| REQUEST FOR INFORMATION |   |                                       |                     |
| RFI # 026               |   | DATE: March 9, 2018                   |                     |
| <b>Project:</b>         | <b>The Residences at Echelon</b>  | <b>PM</b>                             | <b>Scott Runyan</b> |

| Reference:  | Drawing No: | Detail No:   | Spec. Section: |
|---|-------------|--------------|----------------|
| <b>Footings</b>   |             |              |                |

REF:1/S2.62 (Dt:02.13.17)

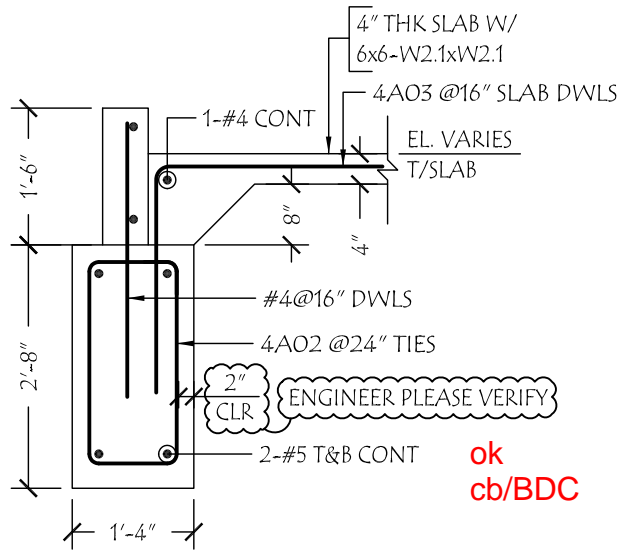
| Reference:  | Drawing No: | Detail No:   | Spec. Section: |
|---|-------------|--------------|----------------|
| <p>The City Inspector would not approve footings yesterday (3/8/18). Drawings indicate 3" clear; however, the reviewed Rebar Shops are approved for 2" clear.</p> <p>Please provide clarification showing 2" cover is acceptable with sealed stamp for the Inspector if this is acceptable.</p> |             |              |                |

The 2" coverage to the support ties for the longitudinal bars is structurally acceptable per response comment (shown below) from the reviewed shop drawing.
